Addendum No. 1

Date: September 20, 2023

Project: KCC Clubhouse

DAG Project #: 22038

A112.2

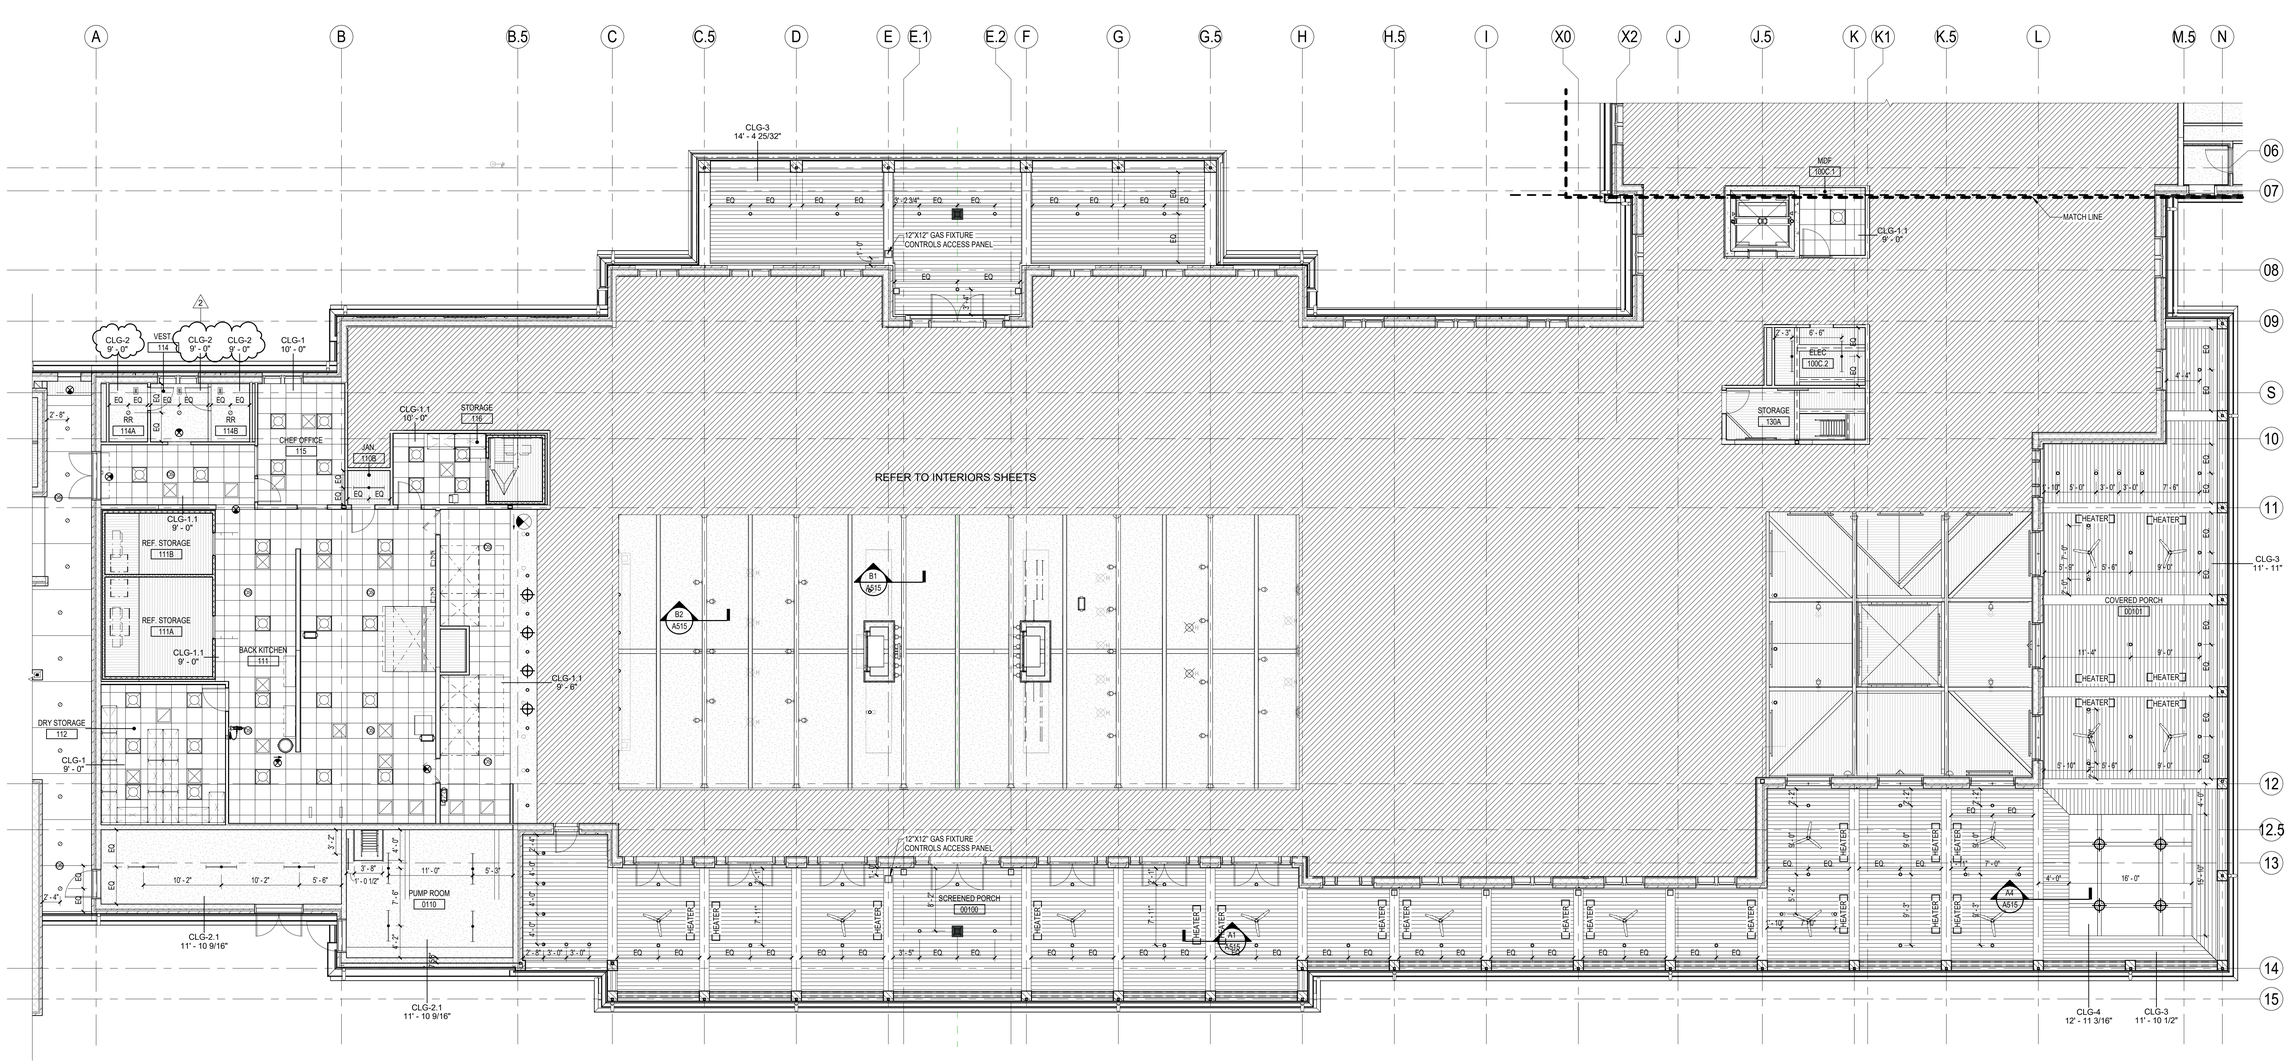
22. Sheet A112.2

- Various dimensions added
    - Joints added to precast on porch

A114.2

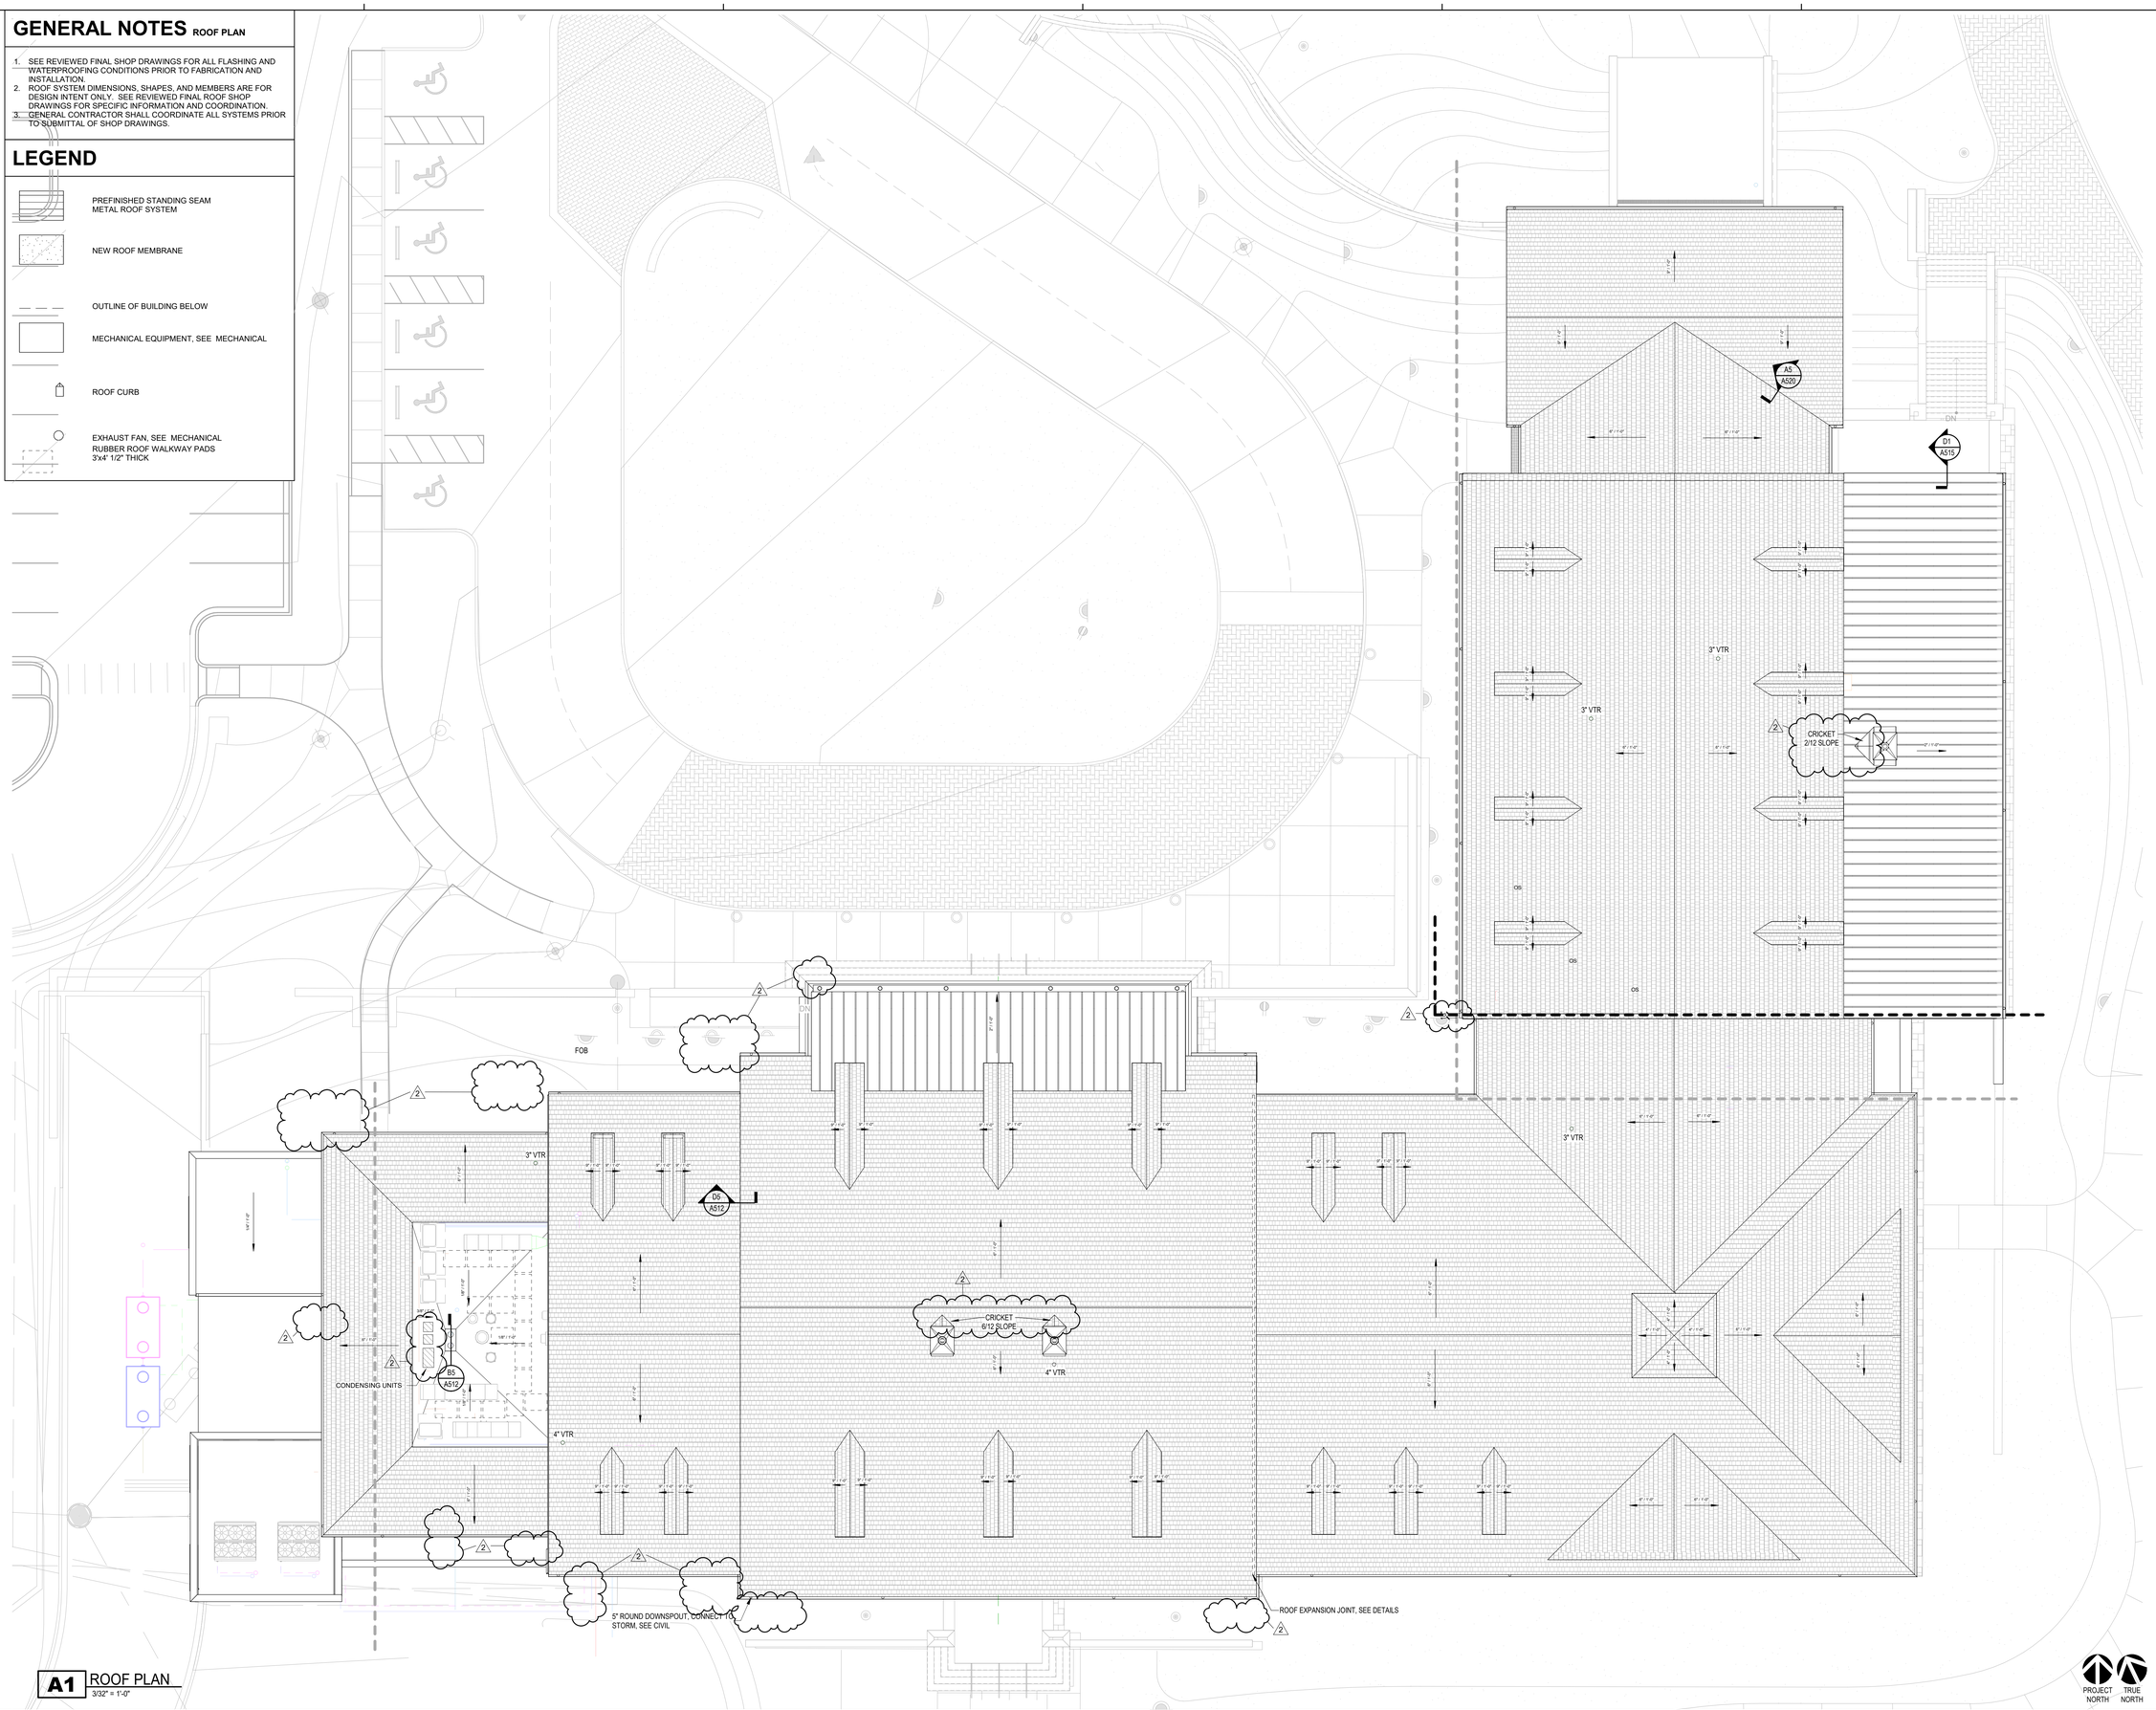
24. Sheet A114.2

- Added dimensions for all exterior porch lighting

A1 PRECAST PROFILES
3" = 1'-0"

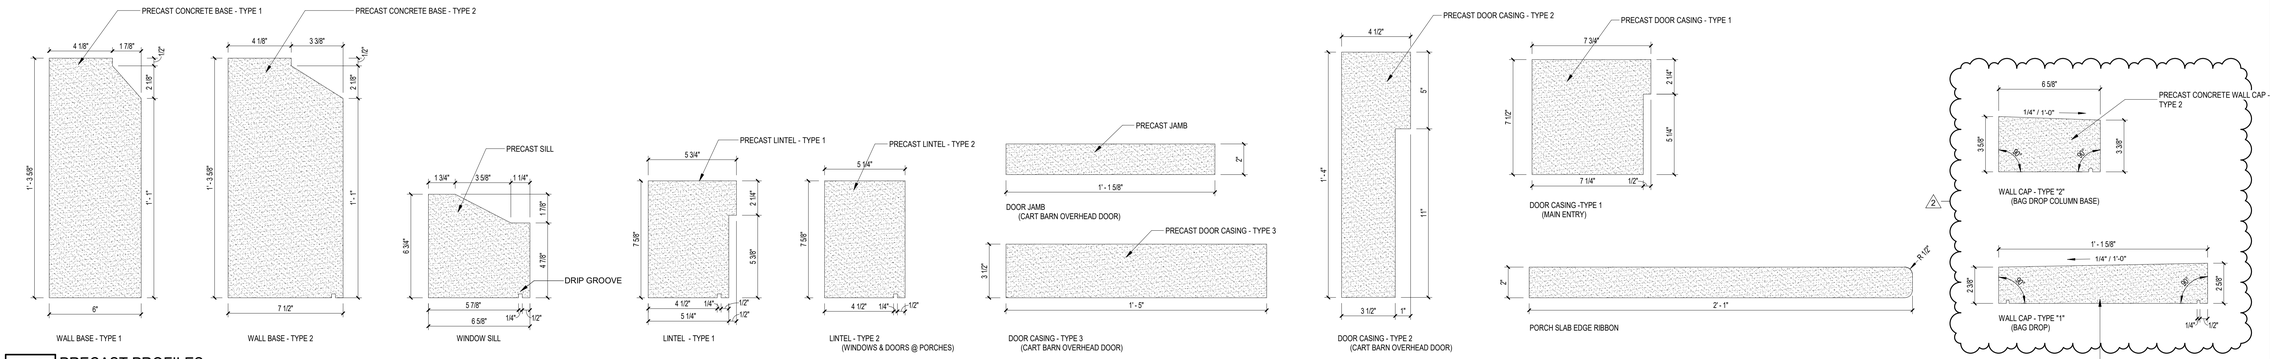
- Changes made to Material Finish Schedule
    - Note added below schedule
    - Exterior wood trim profiles updated – B1
    - Precast profiles added to A1

LC-113A

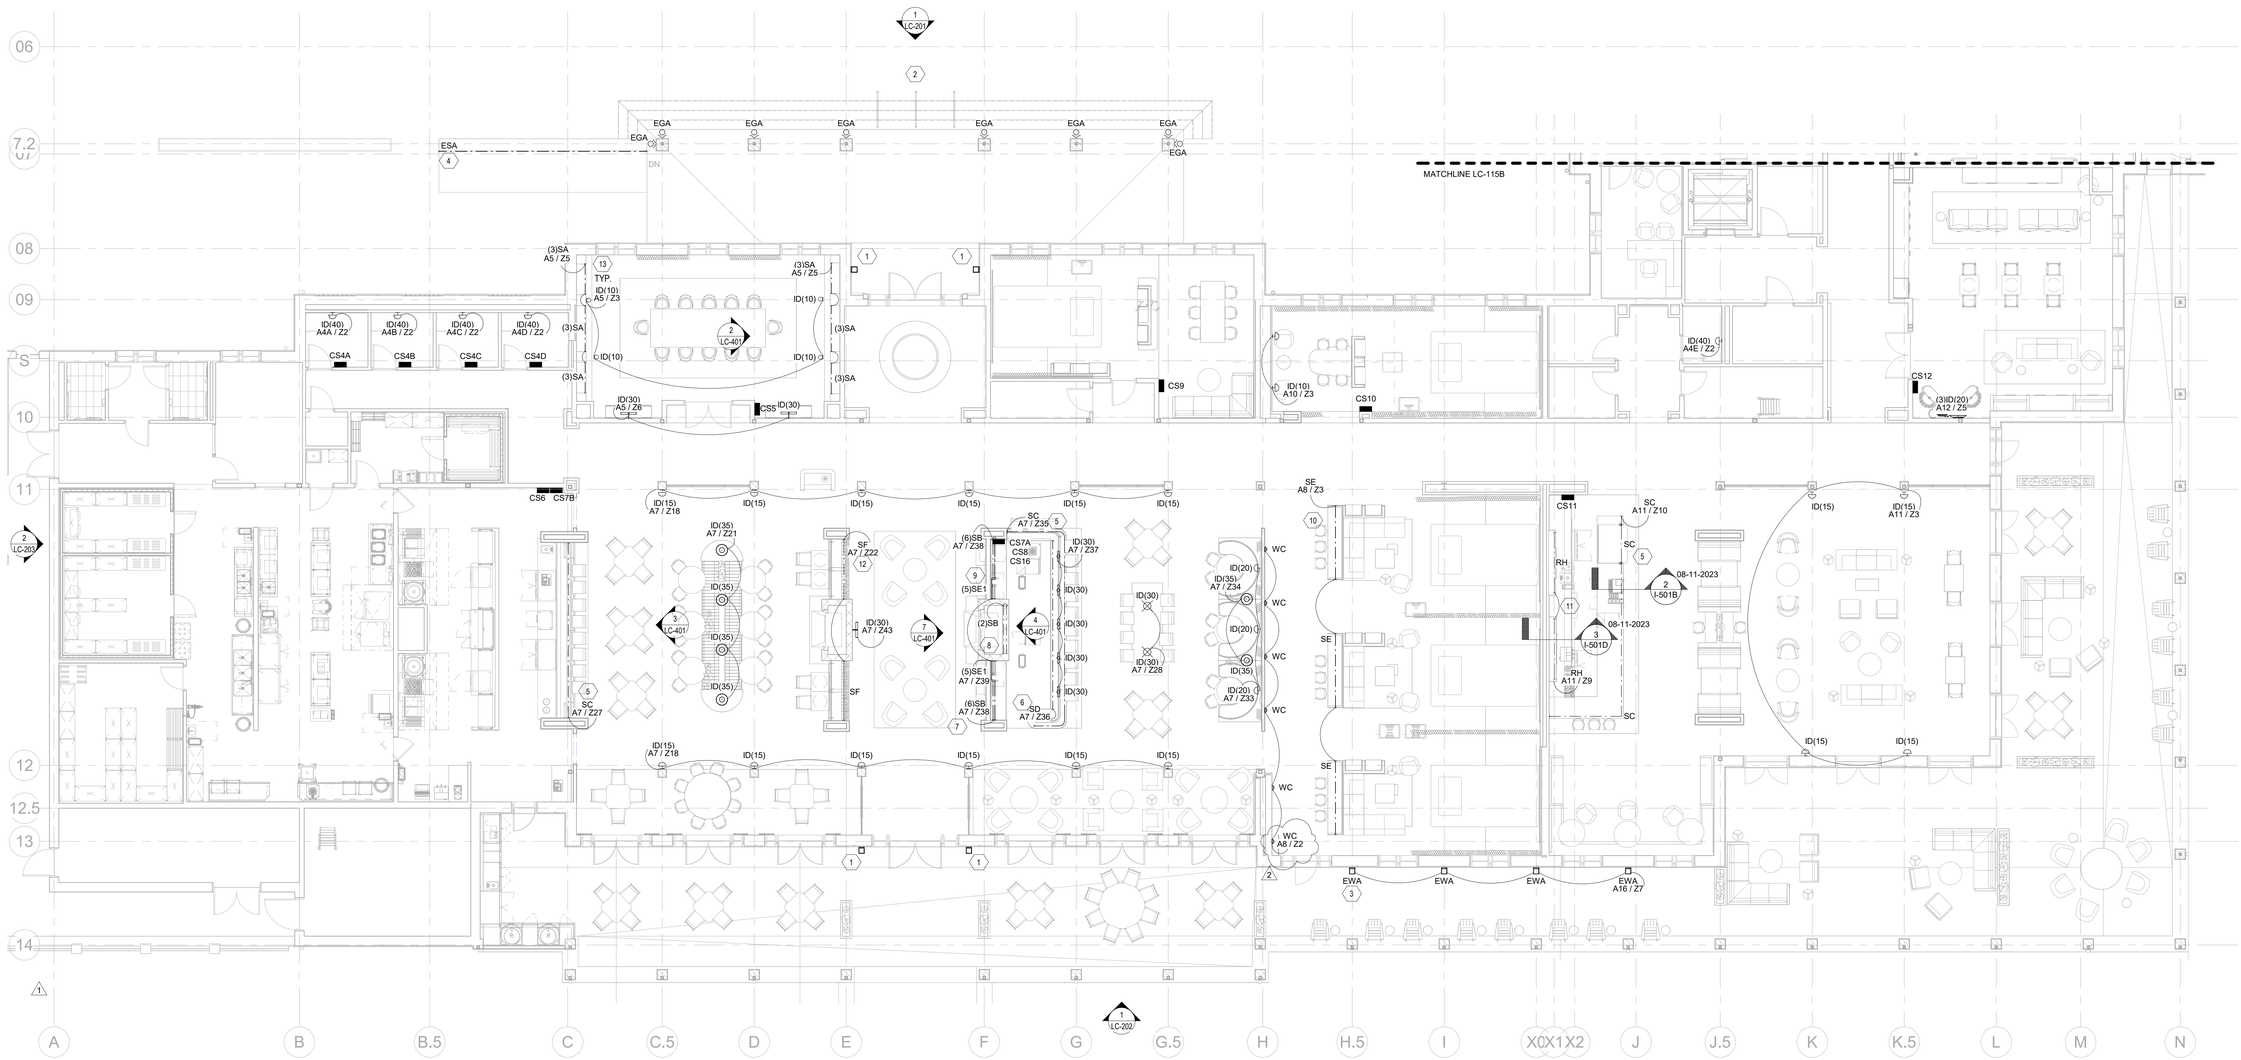
61. Sheet LC-113A

- Downlight in soffit deleted.
    - One RB5, adjustable art downlight, added and pair re-centered on art location.
    - RA downlight centered on door.
    - ERA1 downlights in entry canopy centered between soffit and wall.

LC-115B

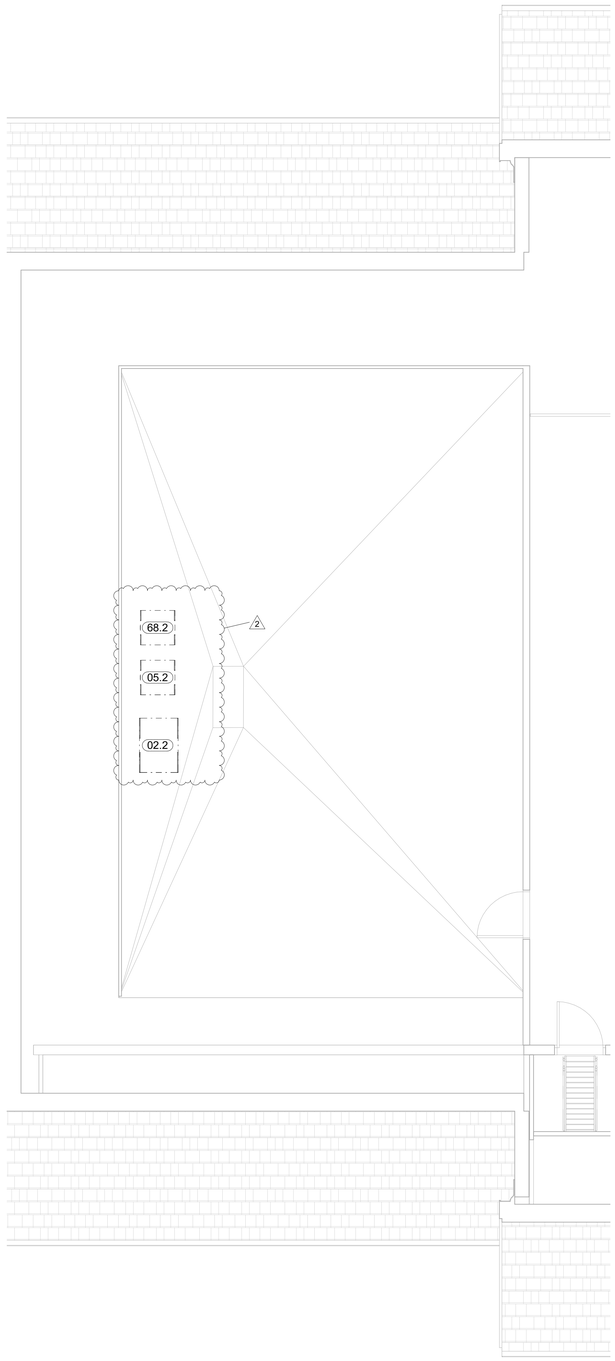
63. Sheet LC-115B

- SE, linear shelf lighting, added in Men's Lounge.
    - SE, linear shelf lighting, added in Women's Lounge.
